UNITED STATES PATENT AND TRADEMARK OFFICE

APPLICATION NO.	FILING DATE	FIRST NAMED INVENTOR	ATTORNEY DOCKET NO.	CONFIRMATION NO.
10/755,535	01/12/2004	Shinichi Fukuda	450100-04883	1332

Office Action Summary

Dodt, Figure 4:

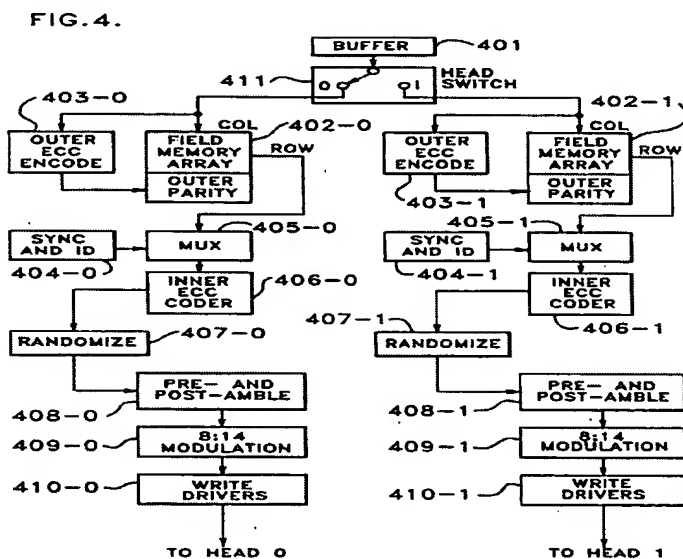
generates said second series code such that a ratio of said second parity to said second series code becomes $1/N$ or more (i.e., Figure 7 and col. 2, lines 40-43). Dodt teaches the first code is generated on per data segment whereas the second code is generated across multiple data segments.

Misawa, Figures 1 and 3:

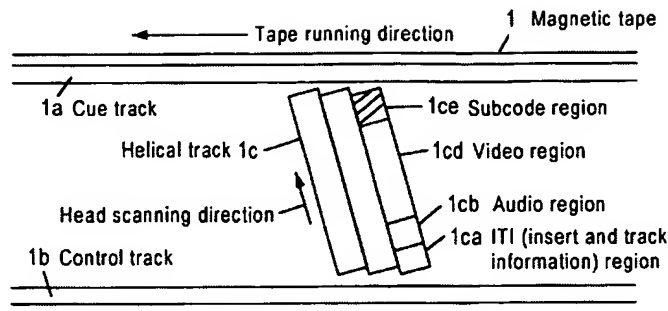
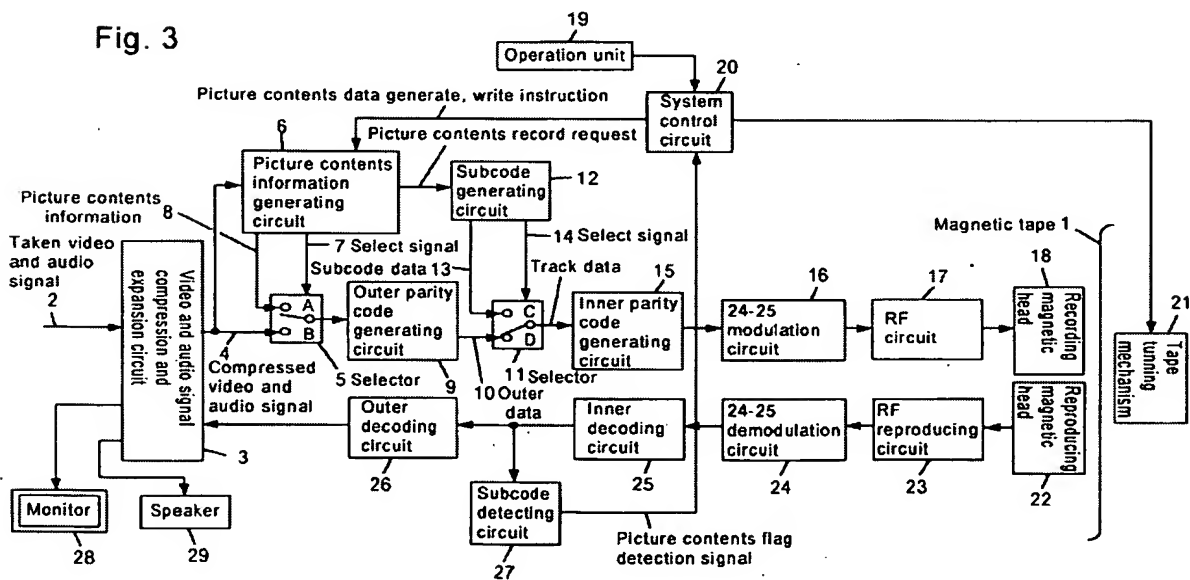
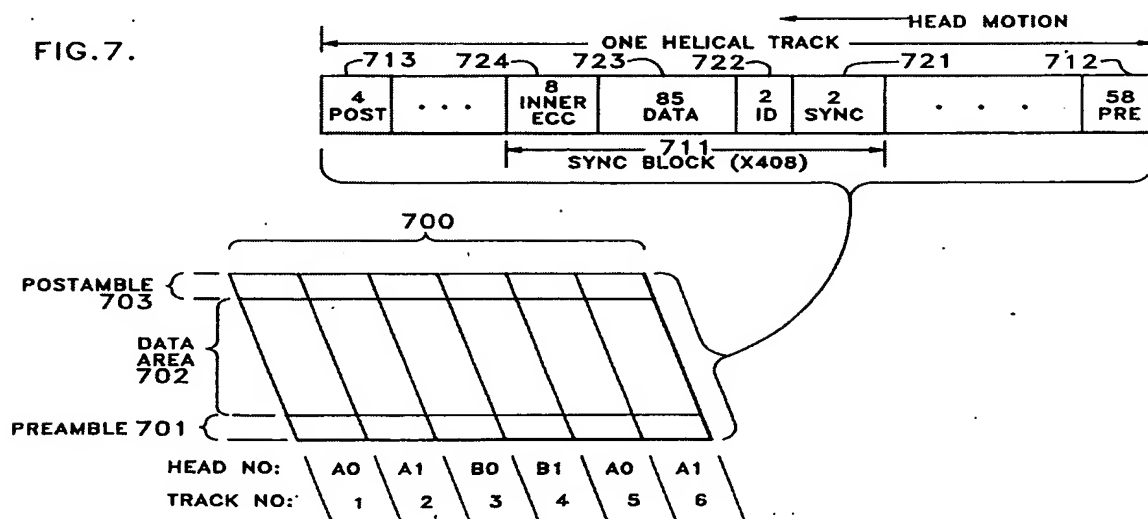
However, Misawa teaches, in an analogous art, (Figures 1 and 3, shown above) a magnetic tape 1 has a cue track 1a in the tape running direction, and a control track 1b disposed at both ends of the tape, and a helical track 1c disposed in the center. Particularly, Misawa teaches (i.e., Figure 3 and col. 4, lines 10-23) an outer parity code generating circuit 9 (analogous to first series code generating means) and an inner parity generating circuit 15 (analogous to

second series code generating means). In other words, Misawa teaches a second series code generating means (Figure 3, reference 15) for generating a second series code by *adding a second parity*. Therefore it would have been obvious to one of ordinary skill in the art at the time the invention was made to make the second series code generating means of Dodt to generate a second series code by adding a second parity. This modification would have been obvious to one of ordinary skill in the art because one of ordinary skill in the art would have recognized that by making the second series code generating means of Dodt to generate a second series code by adding a second parity would have improved on the error detection/correction as well as improved the overall speed of the system during recording and/or retrieval (Misawa, col. 2, lines 35-37).
